From: david@haigconstruction.com
To: [Dan Rieden](#)
Subject: [EXTERNAL]Re: FW: 848 Chicago: Application Questions
Date: Tuesday, September 14, 2021 4:54:11 PM
Attachments: [Unilock LedgeStone pillar caps.png](#)
[Front Walk brick pattern.png](#)
[Bike Hoop BrBs103.png](#)
[Plan landscaping L4.pdf](#)
[Pier Light Dimensions.pdf](#)
[Light Pier Mounted Lexington.pdf](#)
[Bike Hoop BRBS-103 Victor Stanley Site Furniture.pdf](#)
[Plan landscaping L-3.pdf](#)
[Rivercrest® Wall - Unilock Commercial.pdf.pdf](#)
[Richcliff® - Unilock Commercial.pdf.pdf](#)

On Mon, Sep 13, 2021 at 11:59 AM Dan Rieden <riedenda@detroitmi.gov> wrote:

I have series of questions with regards to your application. I would appreciate your prompt response on these as we are trying to finalize the review. Please respond to the following questions by end of day tomorrow.

Pic #11 848 Chicago
Restored Basement
Door North Elevation

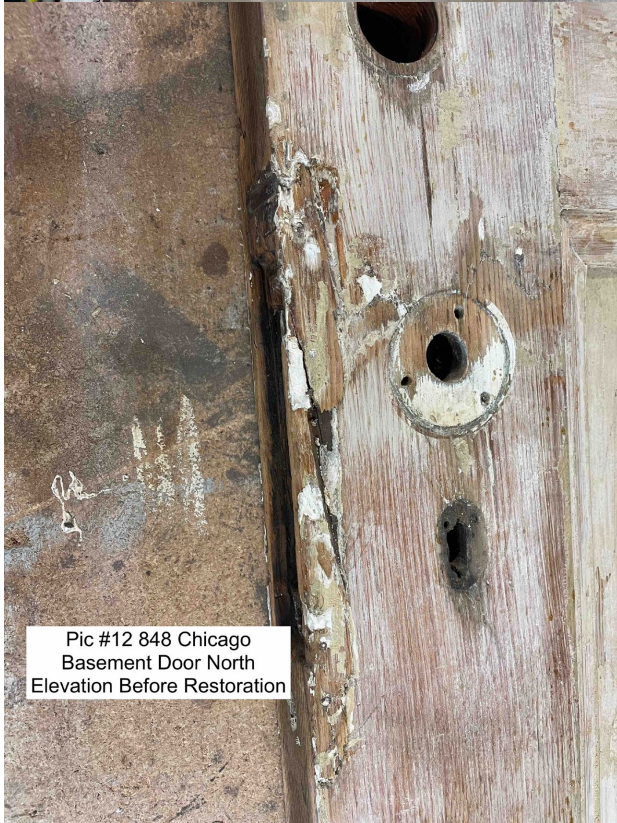
14. Are there any painting scope items that we should include in the application for door/window trim? If so, please provide paint product as you have for the door repairs.

I have repainted all the storms new and old with Sherwin Williams 2829 classic White One rear door has been restored and repainted after someone tried to kick it in at a previous date making it very hard to lock.

See:

Pic #11 848 Chicago Restored Basement Door North Elevation,
